RTB Correction

Reissue date : **15-Jun-98**

Model: AD1(LCT Option)		Date: 31-Jan-98	No: 48A
Subject: Paper jam and Noise		Prepared by: K.Ugaeri	
From: QAC Field Information Dept.			
Classification:	<input checked="" type="checkbox"/> Troubleshooting	<input checked="" type="checkbox"/> Part information	<input type="checkbox"/> Action required
	<input type="checkbox"/> Mechanical	<input type="checkbox"/> Electrical	<input type="checkbox"/> Service manual revision
	<input type="checkbox"/> Paper path	<input type="checkbox"/> Transmit/receive	<input type="checkbox"/> Retrofit information
	<input type="checkbox"/> Other ()

1.LCT UNIT 1(A667)

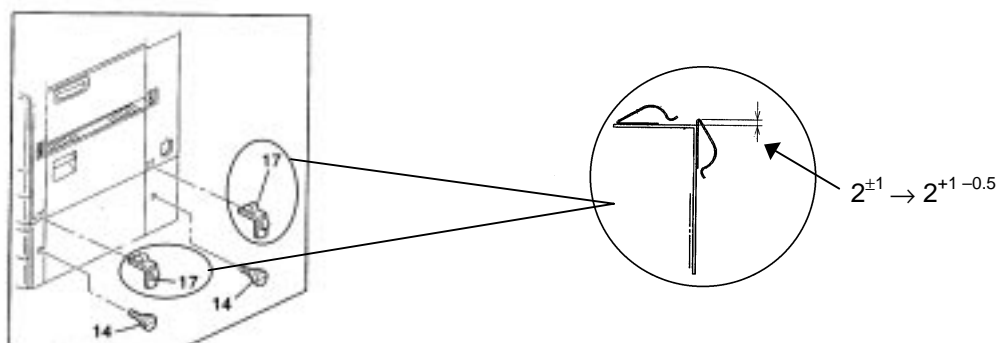
1. The grounding plate (A6676151) was broken at installation.
2. Paper jam
3. Noise

1. When the LCT is installed on the main frame, the spring plate might be cracked.
2. When the dust rubbed off the timing belt gets between the timing pulley and the drive shaft, the rotation of the pulley is affected and paper jams might occur.
3. Rotation noise from the relay roller (but the noise level is still within specification)

1. When installing the LCT, take care not to press the grounding plate too hard.

The shape of the grounding plate has been modified (A6676151->A6676151A) and RCL will supply the countermeasure parts to each subsidiary.

3.LCT UNIT 3 (A667)

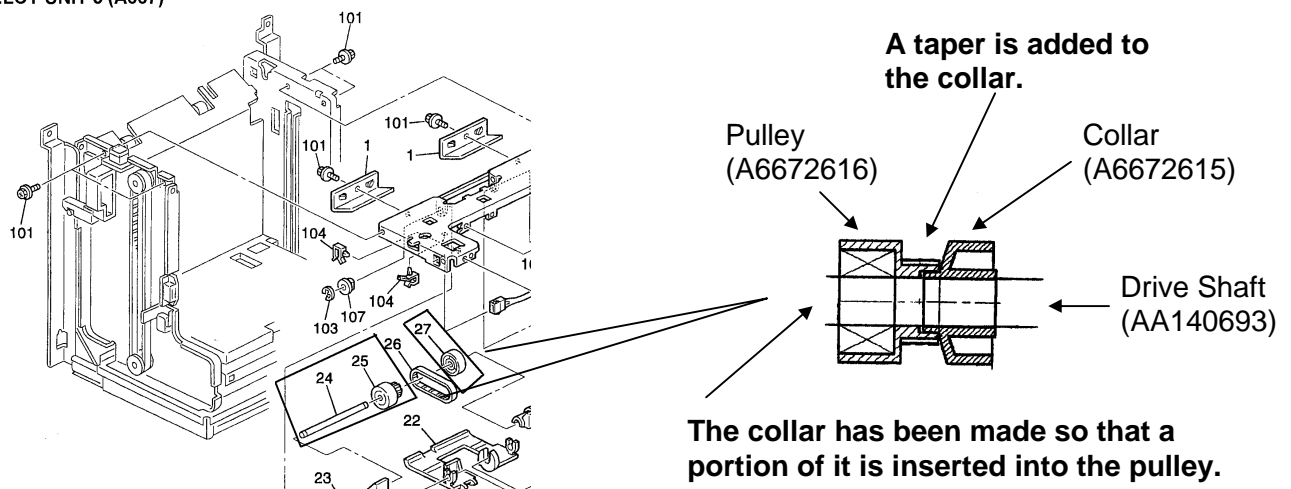
2. Clean the drive shaft of the timing pulleys (P7 – Index 24,**25,27**).

To prevent this problem in the LCT, the material of the shaft and the shape of the pulley and collar have been modified to reduce the dust from the timing belt and to prevent the dust from getting into the pulley. RCL will supply the countermeasure parts to each subsidiary.

1. AA140627 → AA140693 **Drive Shaft – Feed Roller**
 2. H5154713 → A6672615 **Timing Pulley Collar – 6x8**
 3. H5154714 → A6672616 **Timing Pulley – 22Z**
- } X/O as a combination

The interchangeability for these parts is available as a combination.
